**Office of River Protection, State of Washington Department of Ecology
Tank Waste Retrieval Work Plan/Functions and Requirements Change Notice
(Per Hanford Federal Facility Agreement and Consent Order Section 9.3)**

1. Document Title and Number: RPP-22520, Rev. 8, 241-C-101 and 241-C-105 Tanks Waste Retrieval Work Plan		
2. Minor Field Change: (Section 12.4 HFFACO Action Plan) <input type="checkbox"/> Yes: (WRPS Signature Only – Attach signed form to Primary Document for record purposes) <input checked="" type="checkbox"/> No: Proceed to Box 3	3. Document Issue Date: 03/18/14 4. Document Modification Notice Date: 1/18/16	5. Notice Number: 2016-01

9. Description and Justification of Change: Change Description: A third technology is needed to retrieve the waste from tank 241-C-105. The third technology requires equipment and operational changes and that are described in the modified TWRWP. Justifications: <ul style="list-style-type: none">• Section 1, page 1-1: updated the leak status of C-105 and updated the Consent Decree reference.• Section 2.1, page 2-1: Updated retrieval schedule status.• Section 2.4, pages 2-6 and 2-12: updated the least status of C-105.• Section 2.5, page 2

Figure 3-3: Tank C-105 Third Technology Waste Retrieval System In-Tank Components

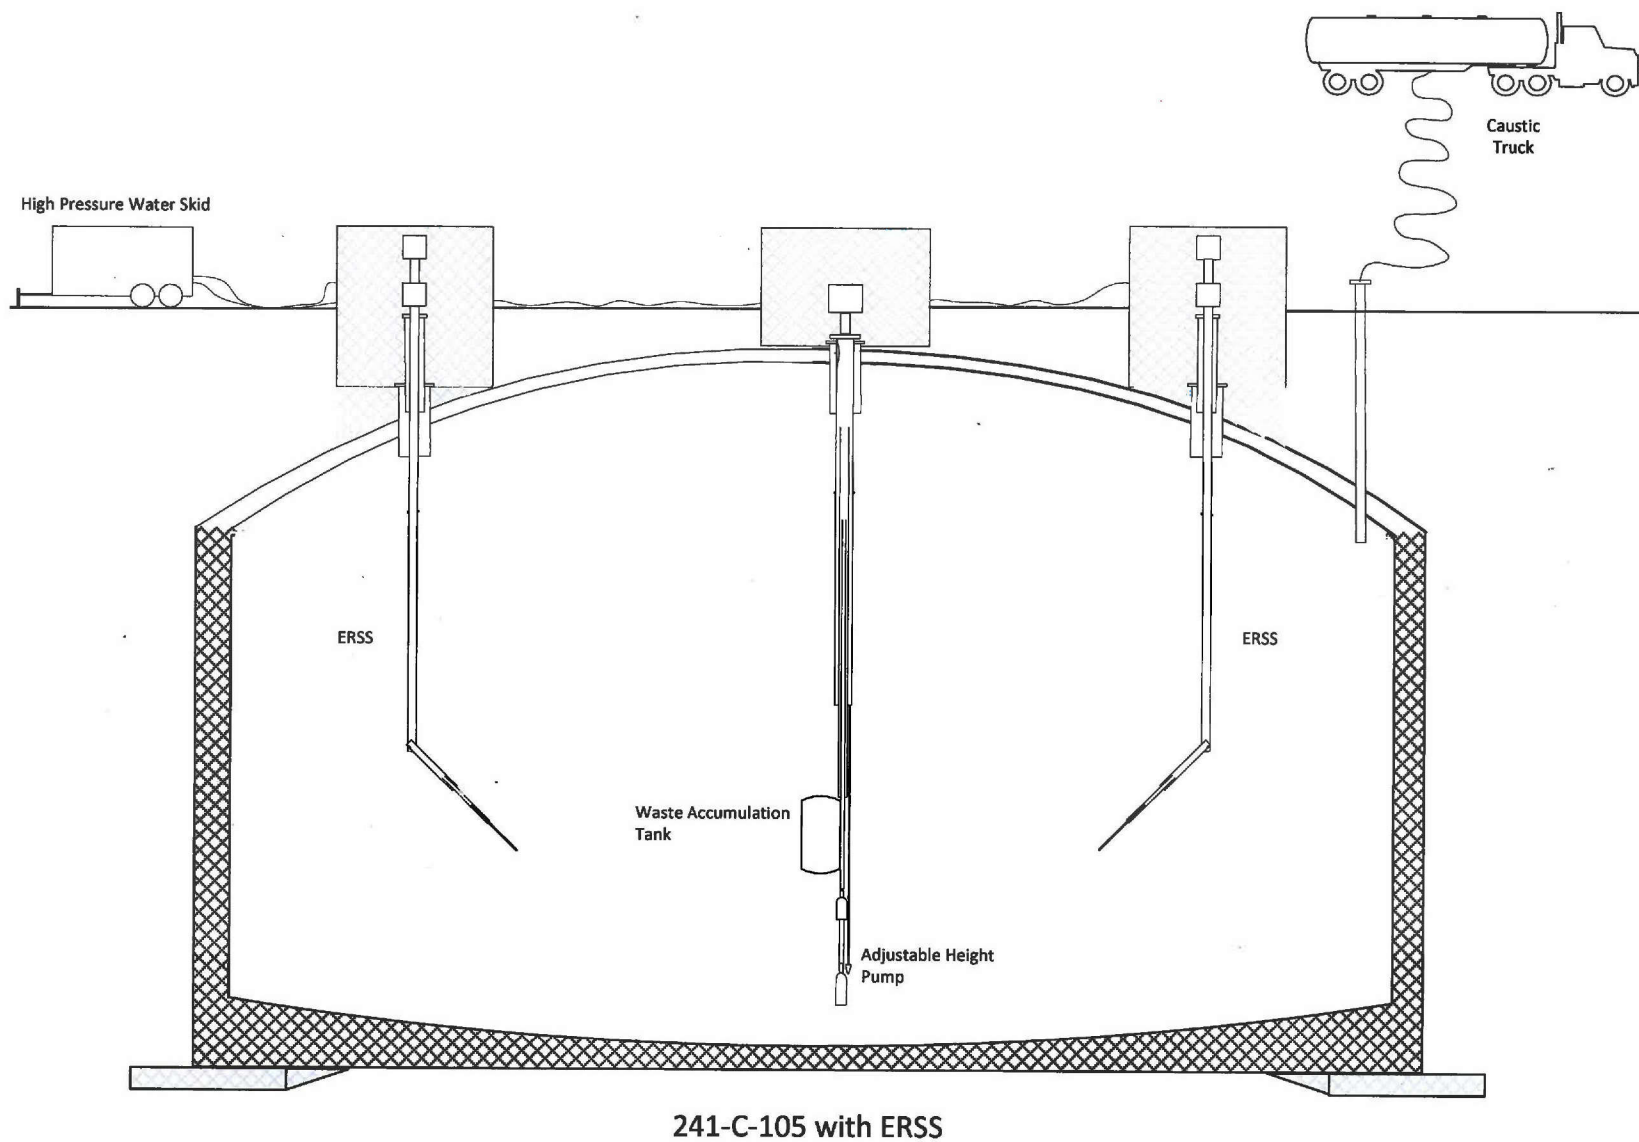
The MARS-V retrieval system was only able to retrieve about 45% of the waste in tank C-105. Even though retrieval goals were not met, the retrieval system operated as designed with a few operational adjustments. The arm function operated well and moved the end effector in close proximity to the waste. The vacuum was strong and the system operated for approximately 1,500 hours before a critical hose failure disabled the system. The waste was more viscous and had more agglomerates than anticipated and the mobilizing supernate was nearly saturated with phosphate. The waste picked up by the vacuum eductor plugged the nozzle. When high pressure water was used to mobilize the waste, the system was more effective.

In general terms, the SEE team considered two options for tank C-105 retrieval; 1) enhancement and repair of the MARS-V, and 2) installation of a sluicing system. Even if the hose were repaired and the MARS-V system were enhanced to better retrieve the type of waste encountered in tank C-105, other system components are aged and have an increased probability of failure. Also, the MARS-V design does not include a slurry pump that can be raised and lowered into the waste in the tank, so recirculating caustic would be difficult. The evaluation concluded that installation of a sluicing system that would be able to deploy chemical dissolution with caustic was most favorable. Sluicing systems have been used successfully in many tanks and with many types of waste. The sluicers can be used to recirculate added chemicals and the ERSSs can be maneuvered close to hard waste agglomerations that are difficult to break apart. There has been no indication of a leak in tank C-105 and the current leak detection system and operation can be enhanced to increase the probability of detecting a leak.

The waste in tank C-105 contains a high percentage of aluminum relative to other waste components which is readily dissolved by caustic. Caustic is also effective at dissolving phosphate solids and organic materials. If organic binders are present in the waste, sodium hydroxide may dissolve the binders reducing the size of agglomerations. Laboratory testing has shown that the waste in tank C-105 is amenable to caustic dissolution.

Figure 4-3. Leak Detection Methodology for SST Retrieval.¹¹Leak detection using SST level measurement may supersede HRR and drywell monitoring when criteria 4.2.1.2 are met.²Only until HRR is back in service.

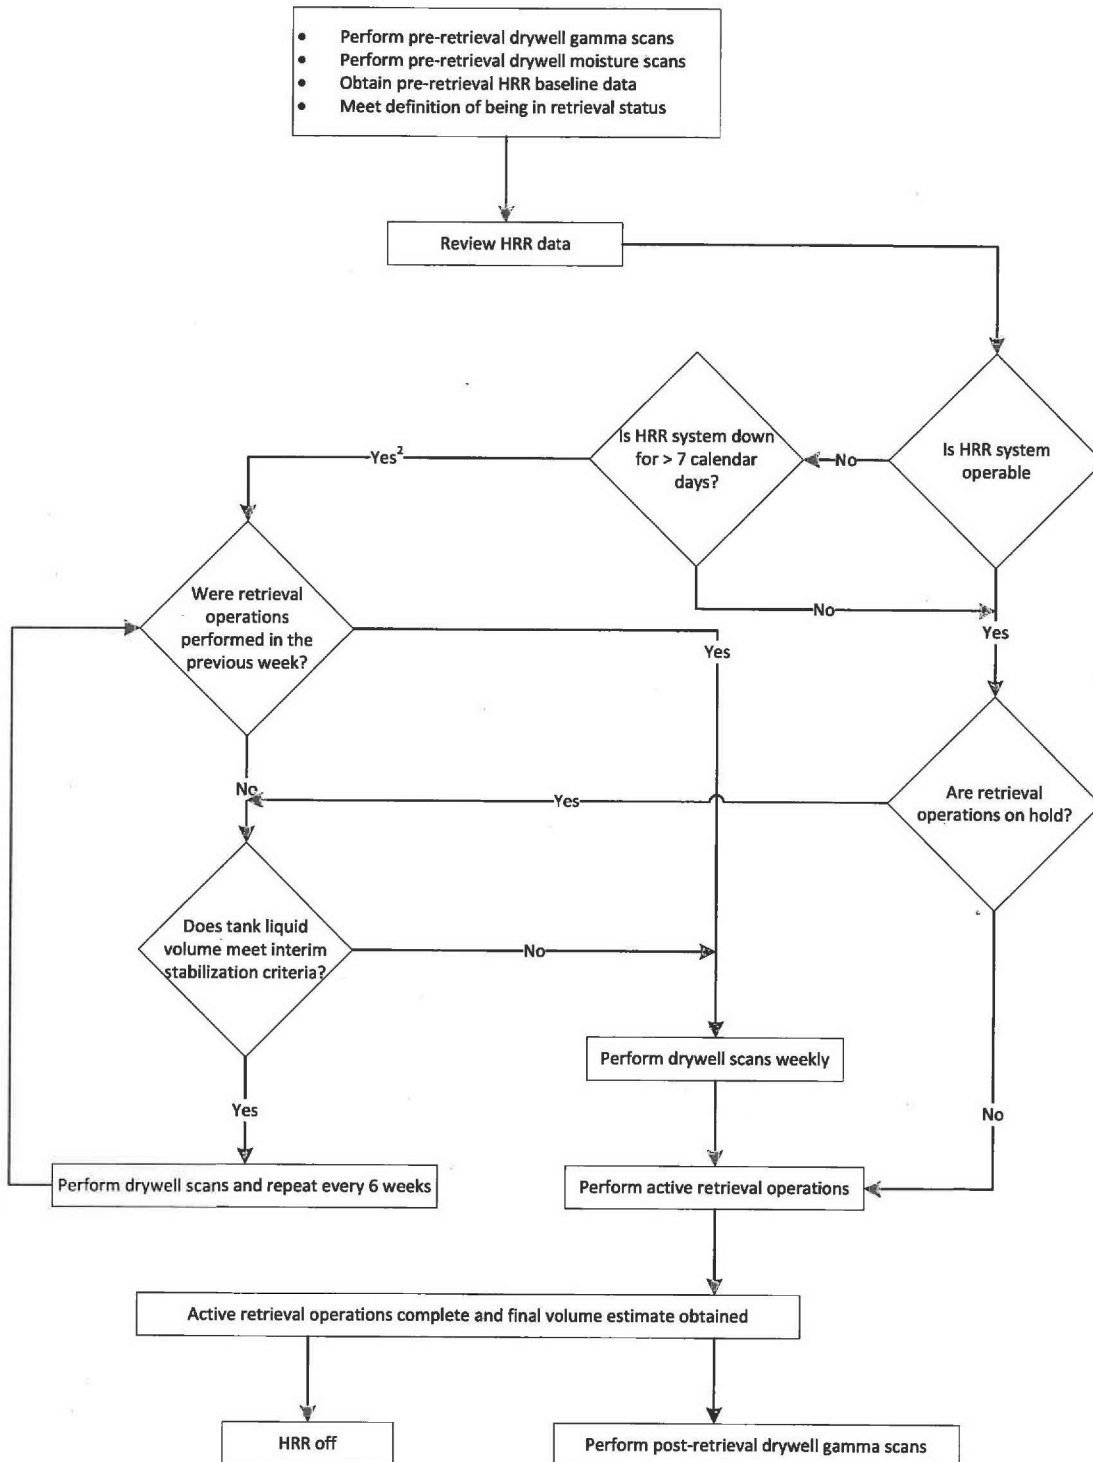
- Table 3-5, page 3-27: Updated Consent Decree reference.
- Section 4.0, page 4-1: Updated Consent Decree reference.
- Section 4.1.2, page 4-3: Corrected sentence with a missing word.
- Figure 4-3, page 4-7: Figure was modified to account for tanks in retrieval status not being actively retrieved.
- Section 4.2.1.1, page 4-8: Added requirement for obtaining gamma scans before deploying the third technology in C-105.
- Section 5.0, page 5-1: Updated Consent Decree reference and clarified sentence.
- Section 7.0, page 7-1: Added missing words, deleted incorrect words, and updated Consent Decree reference.
- Section 9.0, pages 9-2 and 9-9: Reference update and added reference for the system engineering evaluation.
